STAFF RECOMMENDATION
1326 4th Avenue North
November 20, 2019

Application: New Construction—Addition
District: Germantown Historic Preservation Zoning Overlay
Council District: 19
Base Zoning: MUN
Map and Parcel Number: 08209018400
Applicant: Melissa Johnson, Southern Athena
Project Lead: Jenny Warren, jenny.warren@nashville.gov

Description of Project: Application is to construct a new addition. **Recommendation Summary:** Staff recommends approval of the project with the following conditions: 1. Staff shall approve the following materials prior to purchase and installation: a brick sample, all windows and doors, the roofing material and color, the material of the hood, and the side entry step and stoop material. 2. Staff shall approve the location of the HVAC units and all other utilities. With these conditions, staff finds that the proposed demolition and addition meets Sections III.E., V., and VII. of the design guidelines.	**Attachments** **A:** Photographs **B:** Site Plan **C:** Elevations

Figure 3. Proposed rear elevation. Note eave heights.

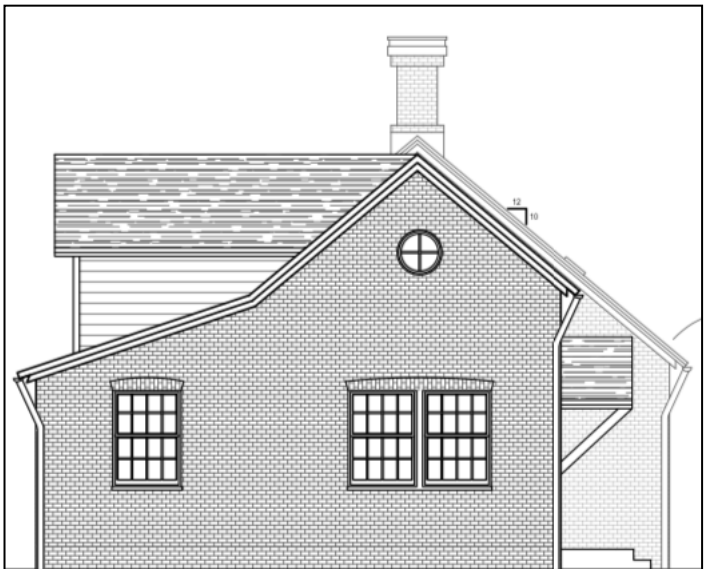
Height/Massing: The addition will be one and a half stories and will be approximately twenty-two feet (22') high at the ridge, which is one foot (1') lower in height than the existing structure. The proposed eave height along Taylor Street is about four feet (4') higher than the eave of the historic house. While the guidelines state that the eave height on an addition should be less than or equal to the eave height of the historic house, staff finds that the increased eave height could be appropriate in this instance. When viewed from the back of the addition (Figure 3), keeping the new eave higher allows the ridge of the addition to line up to the historic ridge, keep the same 10/12 slope and still have an inset from the historic side wall along Taylor Street. With the ridge aligned, matching the eave height would create a very steep roof slope facing onto Taylor Street. For these reasons, staff finds that the proposed eave height on the left side could be appropriate. On the interior side, the eave of the addition will match the eave of the historic house.

The overall width of the addition will exceed the width of historic structure by about one foot (1'). This massing will be shifted, such that the addition will step wider than the historic house on the right side. As described above, on the Taylor Street elevation, the addition will be inset from the historic house (which sits on the left side property line) about six feet (6'). On the right side, the addition will be set in one foot (1') for a distance of two feet, five inches (2'5") and then will step out to be seven feet (7') wider

than the historic house. The guidelines allow for additions that step wider than an existing historic building when the building is narrower than thirty feet (30') or is shifted on the lot. This site satisfies both conditions: the historic house is only twenty-seven feet (27') wide and is shifted to the left of the lot. The guidelines also state that a wider addition should not wrap the corner; the proposed insets on both sides allow the retention of the original rear corners of this historic house.

2 A–0 PROPOSED SITE PLAN

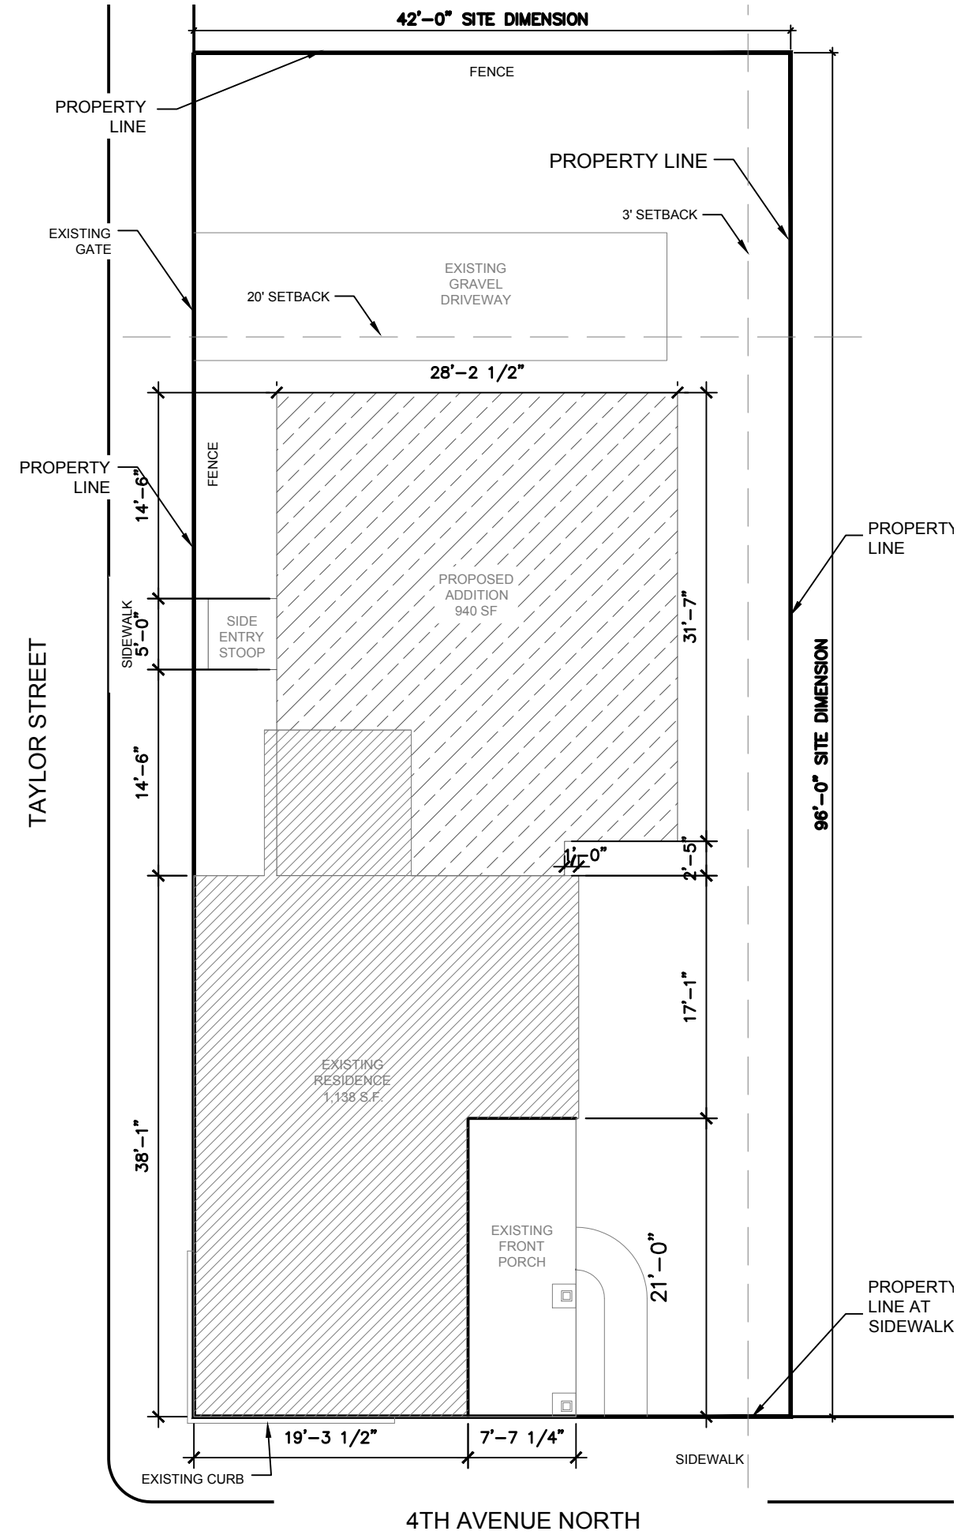
Setbacks. The proposed addition meets all base zoning setbacks. Base zoning requires three-foot (3') side setbacks, which the proposal meets for both sides. The addition will step back from the existing historic structure along Taylor Street, with the side wall being about six feet (6') from the property line. On the right side, it will be about eight feet (8') from the interior side property line. Base zoning requires that the structure be twenty feet (20') from the rear property line, it is proposed at twenty-four feet (24'), so meets this requirement as well. Staff finds that the proposed setbacks meet Sections III.E.2. and V. of the design guidelines.

Placement: The proposed addition is located at the rear of the structure, where it will not disturb either the front or side façades of the historic structure. The addition includes a large dormer facing the interior side property line. The dormer will be inset two feet (2') on all sides, as per the guidelines. Staff finds the placement of the addition to be appropriate and to meet Section V.B. of the design guidelines, for Placement.
